ESTERO DESIGN REVIEW COMMITTEE

Public Meeting
December 17, 2014 at 5:00 PM
The Estero Recreation Center
9200 Corkscrew Palms Blvd.

APPLICANT: Marriot at Coconut Point
Location of Project: Coconut Point DRI
Presented by: Tom McLean – Hole Montes Associates

Originally presented to
EDRC on
December 17, 2014

EDRC/Public Responses – Signage

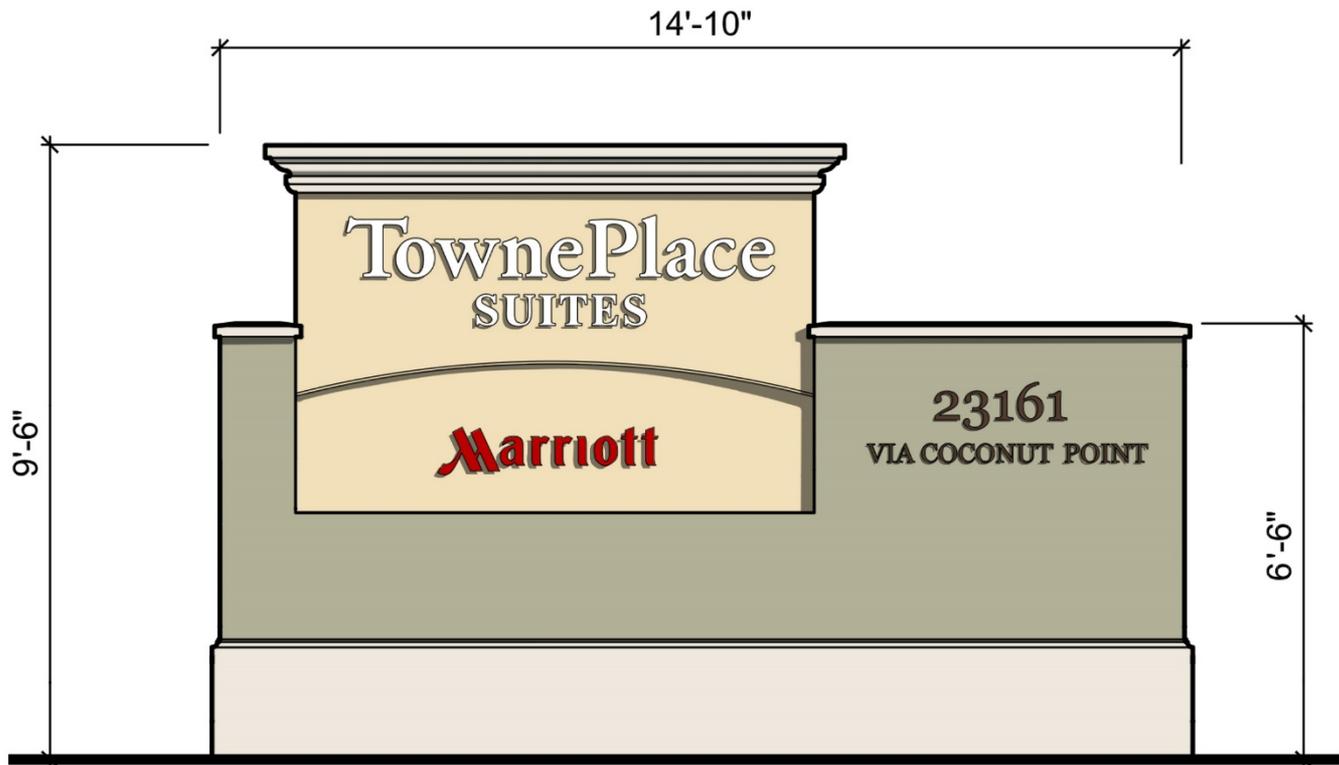
- Applicant conforms with Marriott prototype and the Estero requirements.
- Wall signage proposed each 64 sf in area.....Sign has been modified to blend into the surrounding area.
- The EDRC/Public noted that the base height is too small and EDRC was concerned about losing it with plantings.
- The EDRC/Public recommends **increasing the height to at least thirty-six inches** to better incorporate the proposed landscaping.

EDRC/Public Responses – Landscape Architecture

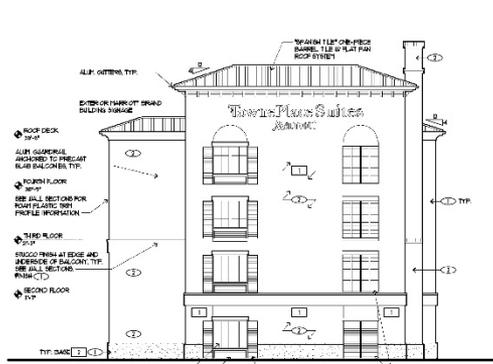
Greg Diserio, Landscape Architect presented the Landscape Design. All noted that the design was in compliance and exceeds required materials to buffers with added berming in front of the parking area to better shield the parking from the adjacent Via Coconut Point. Some material was added with larger heights mixed with smaller species to create a more human scale and transition for the pedestrian. EDRC specifically thanked the Applicant for increasing the density of the front buffer as committed to during public presentations to the ECPP. The buffer widths are 15' street tree planning buffer rather than 20' per the Coconut Point DRI.

The EDRC/Public asked about the dry detention area north of the project as being a current eye sore... if the Applicant or if Simon was going to increase or do something.....south edge also... Nothing was assured or resolved in this matter as it is off of the Applicant's property.

The dry detention area to the north is currently owned and maintained by the Coconut Point – Area 2 Property Owners Association. We do not have the ability to make changes to this area.
